PROBLEM:

CORRECTION:

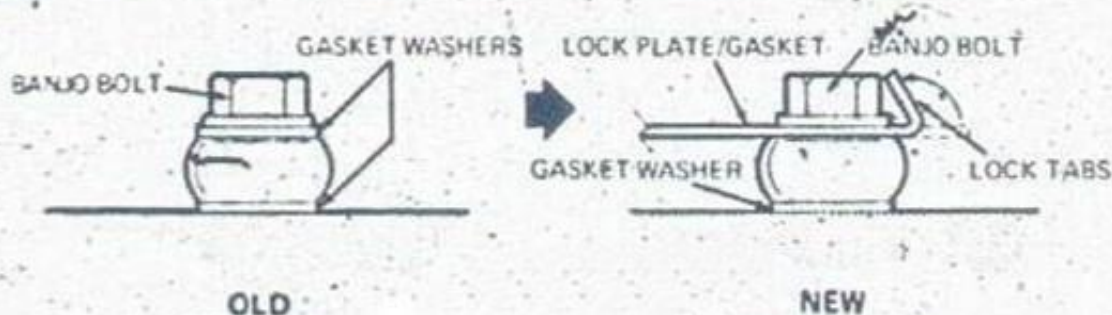
On three-cylinder models, there has been a tendency for the oil pump banjo bolts to loosen. This allows oil to leak into the side cover instead of into the intended cylinder, resulting in overheating and seizure of the affected cylinder.

To correct this problem, a new lock plate/gasket (P/N 92024-058) has been designed to keep the three output banjo bolts from loosening. This gasket has been used on all S- and H-series motorcycles from engine numbers S1E-10965, S2E-41105, KAE-83625, H2E-30126 and up.

The new lock plate/gasket is easily installed on earlier S- and H-series motorcycles. To install, remove all three outlet banjo bolts and the gasket washers which are on top of the oil lines. Do not remove the washers under the oil lines or on the input banjo bolt. Install the lock plate and banjo bolts, and torque to 24 KG-CM (20 lb.in.). Then bend up all the lock tabs to secure the bolts in place.
